### **Case No. 18ZONE1020 Binding Elements**

CASE #18ZONE1020  
 CASE #14DEVPLAN1033  
 MSD WM #10948

TITLE: REVISED DISTRICT DEVELOPMENT PLAN  
 770 BARDSTOWN RD. & 7509 CEDAR CREEK RD.  
 LOUISVILLE, KY 40291-3207  
 DRAWN BY: DHS  
 CHECKED BY: CRB  
 DATE: 3-1-18  
 DRAWING: 160158-RDDP  
 SCALE: 1" = 30'  
 SHEET: 1.00

**SITE DEVELOPMENT PLAN**

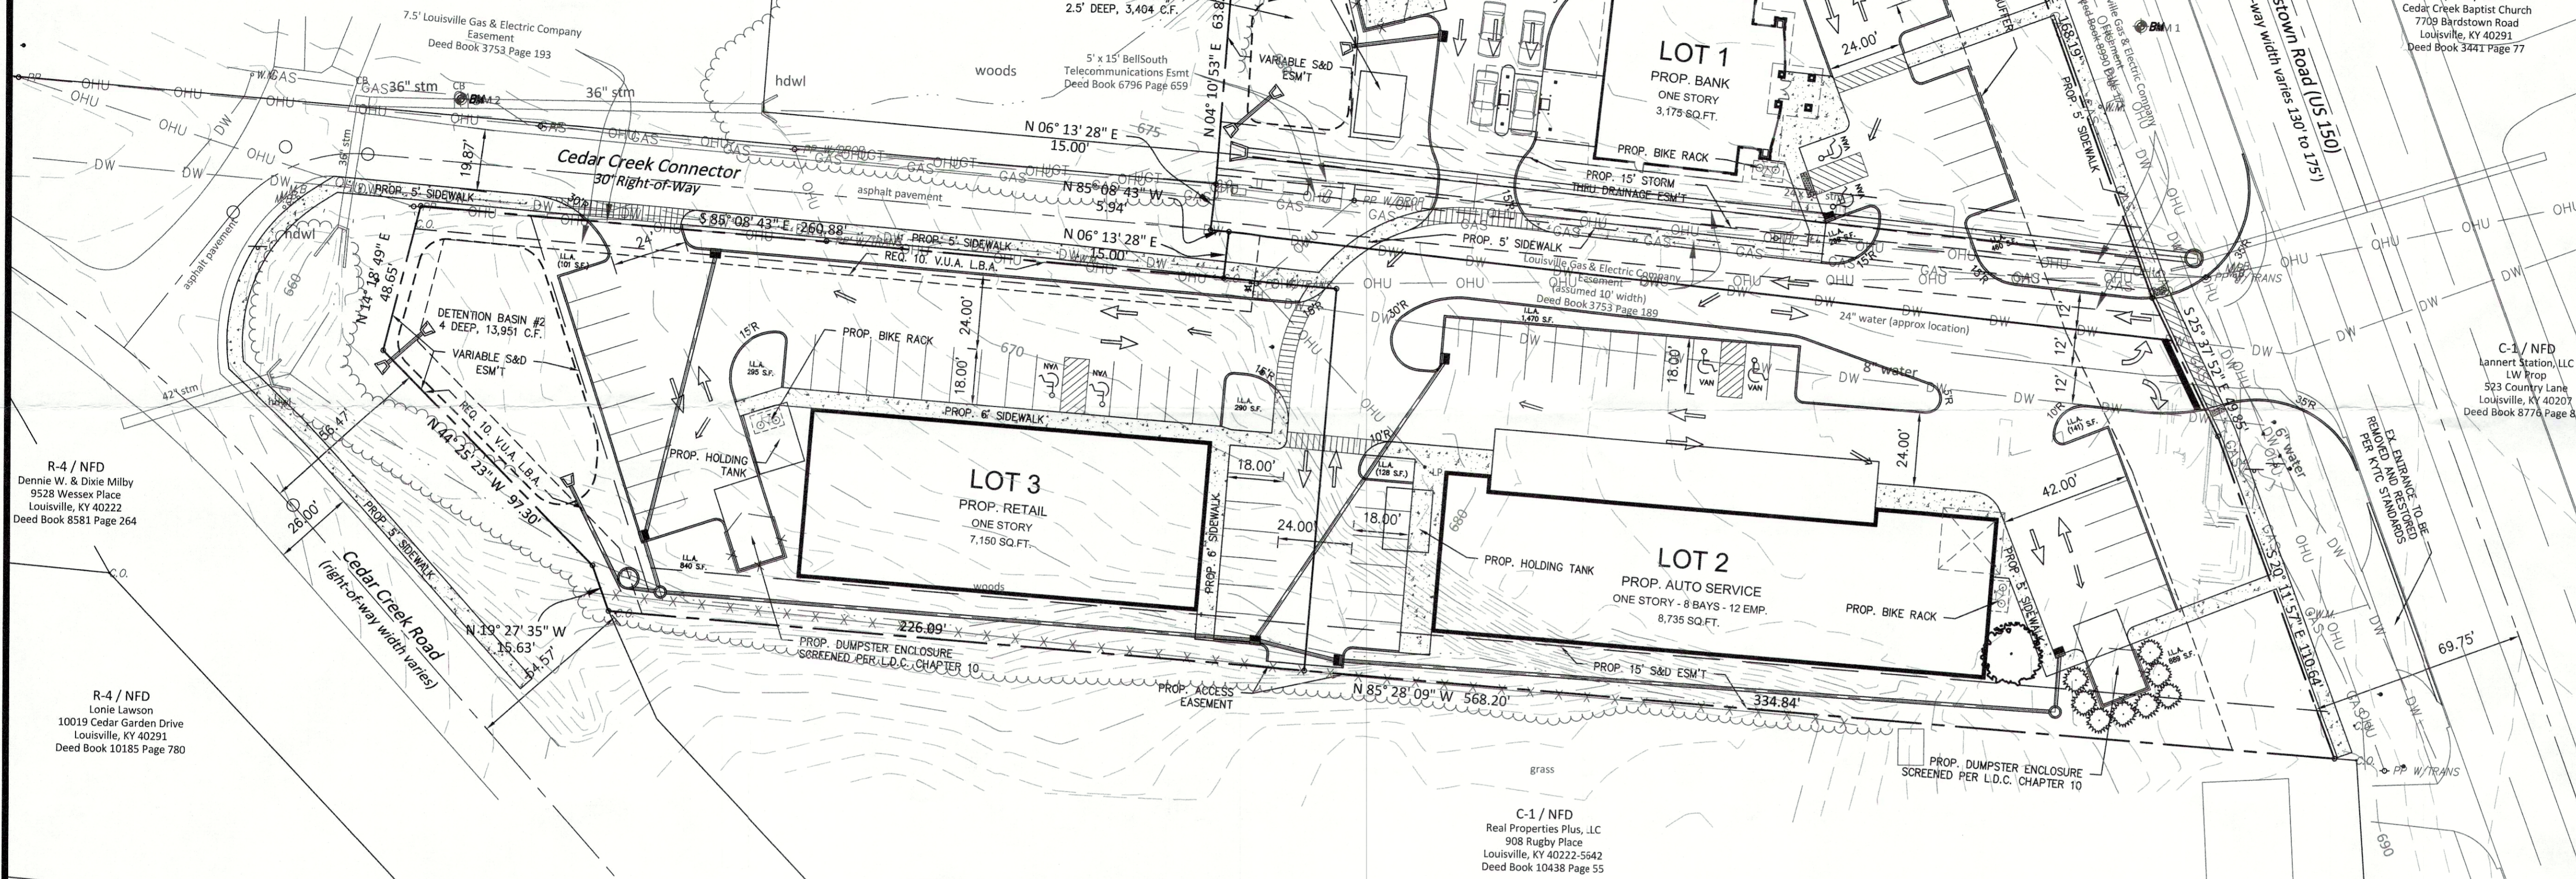
CONDITIONS:  
 Need to add Vary Along Cedar Creek Cor.  
 BY: *Janet W. [Signature]*  
 DATE: *10/27/18*  
 LOUISVILLE/JEFFERSON COUNTY METRO PUBLIC WORKS
